SUBJECT: Forwards proprietary response to RAI re structural aspects of spent fuel pool storage rack mod at Ginna Nuclear Power Plant. Proprietary response withheld (ref 10CFR2.790).

Subject: Response to Request for Additional Information on the Structural Aspects of the Spent Fuel Pool Storage Rack Modification at Ginna Nuclear Power Plant (TAC No. M95759)

Question No. 2:

Figure NRCQ1b.1 PSD Comparison For GINNA SSE1 - Horizontal X

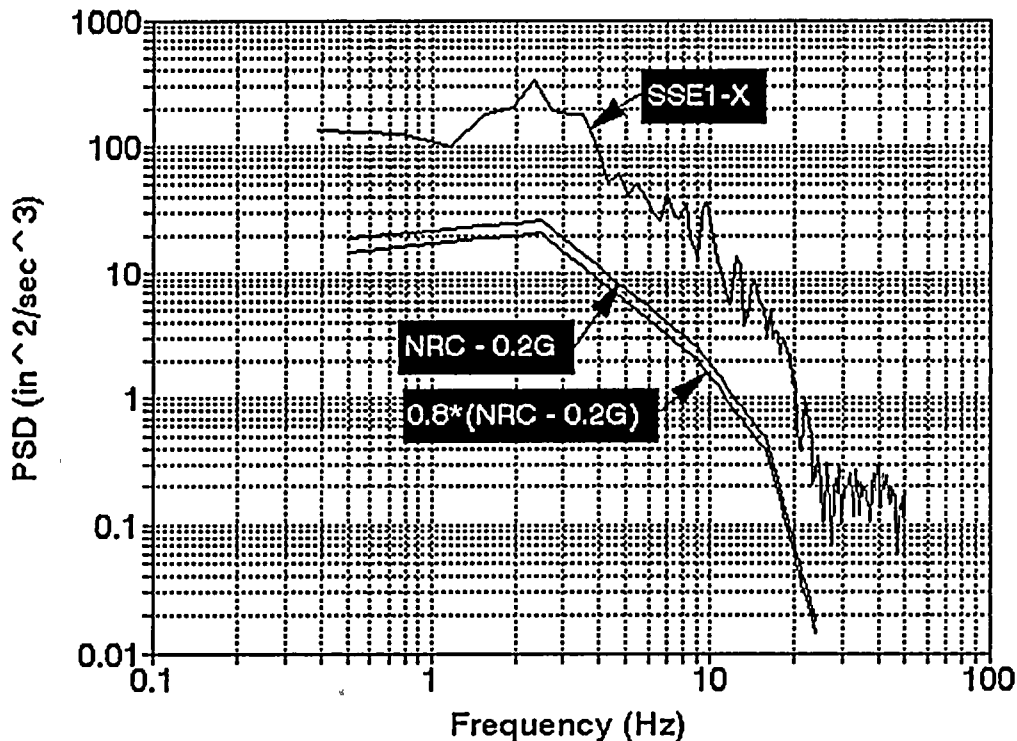
In the staff's RAI dated September 5, 1997, you were requested to provide a power spectral density (PSD) of the artificial time history to demonstrate the adequacy of the time history. You provided a PSD of the time history (SSE1-X) with a PSD function developed from Regulatory Guide (RG) 1.60 spectrum (NRC-0.2G shown on page A-8 of Reference 1). It is interesting to note that the SSE1-X PSD contains energy that is more than about 1.4 to 1.8 times the energy of the NRC-0.2G PSD. RG&E is requested to provide the following:

- (a) Technical discussion of the details as to how the NRC-0.2G PSD was developed. Also, provide sample calculations.*
- (b) The time histories used for the development of the two (SSE1-X and NRC-0.2G) PSD on a 3.5-inch diskette.*
- (c) A comparison between the response spectra (RS) developed using the two time histories indicated in item (b) above.*

- a) The NRC-0.2G PSD scaled target curve (for example SSE-1 Horizontal X, Fig.NRCQ1b.1 in Reference B) is obtained as follows:

The target PSD curve scaling factor is $(0.2)^2 = 0.04$, since the SSE-X1 DRS peak acceleration is 0.2 G. For example, at $f = 2.5$ Hz, the target PSD (based on 1.0G peak acceleration) is $650 \text{ [in}^2\text{/sec}^3\text{]}$. The resulting scaled target PSD value for GINNA (using

the scaling factor = 0.04) then becomes $0.04(650) = 26 \text{ [in}^2/\text{sec}^3]$ in Ref. B, Fig. NRCQ1b.1. A similar procedure is applied for all other frequencies that define the GINNA scaled target PSD curve.

The 80% scaled target PSD curve is labeled as "0.8*(NRC-0.2G)" in Ref. B, Fig. NRCQ1b.1, and represents 80% of the "NRC-0.2G" curve in the respective Figure.

- Notes: 1) Upper curve (SSE1-X) is the PSD for the GINNA time history SSE1-X.
- 2) Middle curve (NRC-0.2G) is the scaled target PSD curve, based on SRP 3.7.1 requirements. The scale factor is $(0.2)^2 = .04$. Therefore, at 2.5 Hz, SRP 3.7.1 specifies $650 \text{ inch}^2/\text{sec}^3$. The scaled target value at 2.5 Hz is $(.04)(650) = 26 \text{ in}^2/\text{sec}^3$. Note that this curve is not based on any time history.
- 3) Bottom curve represents 80% of the middle curve in 2) above. This is the minimum value specified by SRP 3.7.1.
